TRANS/WP.29/GRSG/2001/6
22 January 2001

World Forum for the Harmonization of Vehicle Regulations (WP.29)

PROPOSAL FOR DRAFT AMENDMENTS TO REGULATION No. 66
(Strength of superstructure)

Transmitted by the Expert from Hungary

Figure 1 The residual space"

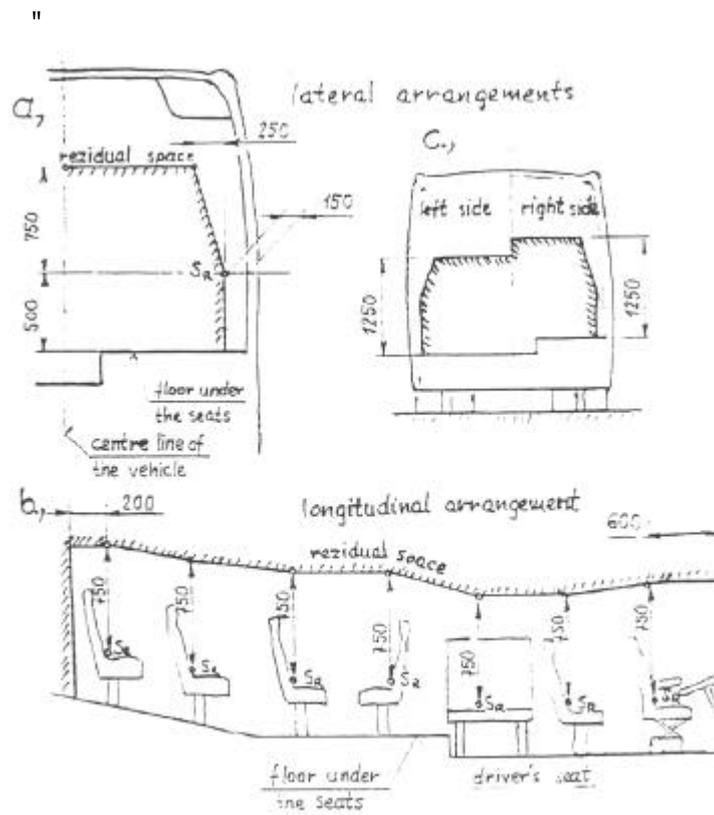
The residual space means the volume within the passenger and driver's compartment determined by a one-one vertical transverse plane on both sides of the vehicle defined in figure 1(a), when these planes are moved along longitudinal straight lines (see figure 1(b)) with the following instructions:

- 5.2.5. the residual space is continuous between its rearmost and foremost border plane.
- 5.2.6. if the two sides of the vehicle are not identical (symmetric) related to the seat floor arrangement and the height of the theoretical S_R points, the step between the two heights of the residual space shall be in the longitudinal vertical centre plane of the vehicle (see figure 1(c)).

Figure 1, amend to read:

Figure 2 Definition of contour

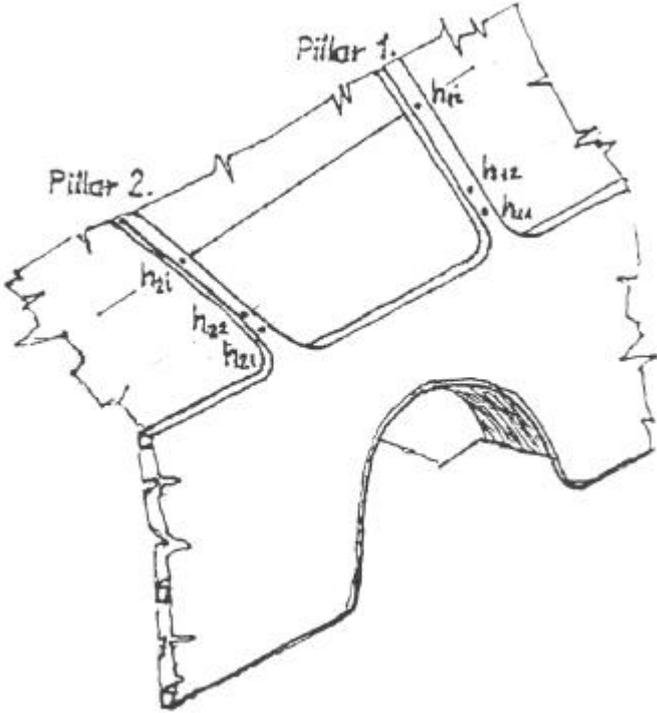
- 5.1.1. No displaced part of the vehicle shall intrude into the residual space, which were out of it before the test (e.g. pillars, safety rings, luggage racks, etc.). All the structural parts, which are originally in the residual space (e.g. vertical handholds, partitions, kitchenettes, toilets, etc.) shall be ignored, when evaluating the harm of the residual space.
- 5.1.2. No part of the residual space shall project outside the contour of the deformed structure. The contour of the deformed structure should be determined step by step, between every two windows and/or door pillars. In one segment, between two deformed pillars the contour is a theoretical surface, determined by straight lines running through the inside contour points of the two neighbouring deformed pillars having the same height above the floor level before the rollover test. (see figure 2)

Insert new figures 2 and 3, to read:

Figure 3 Rollover test with complete vehicle"

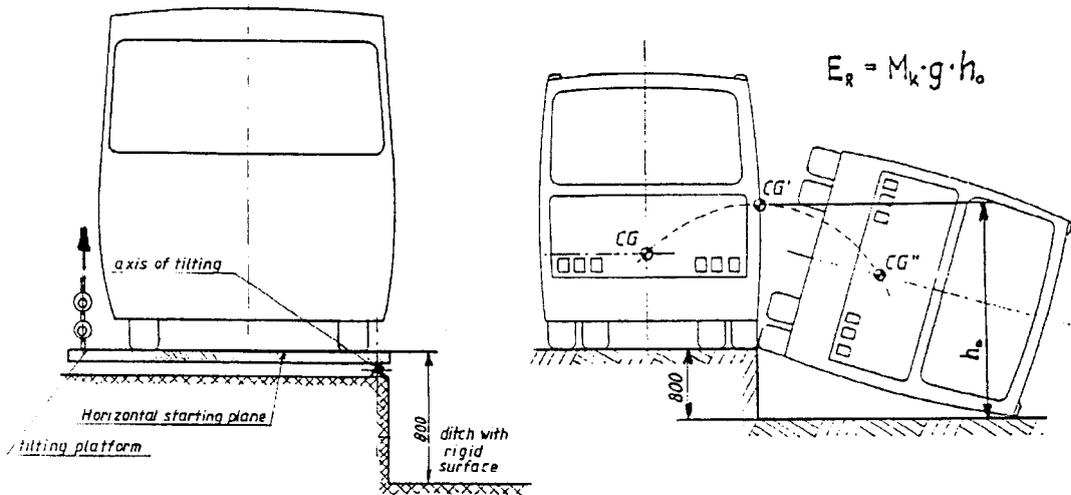
The rollover test is a lateral tilting test, shown on figure 3. and specified as follows:
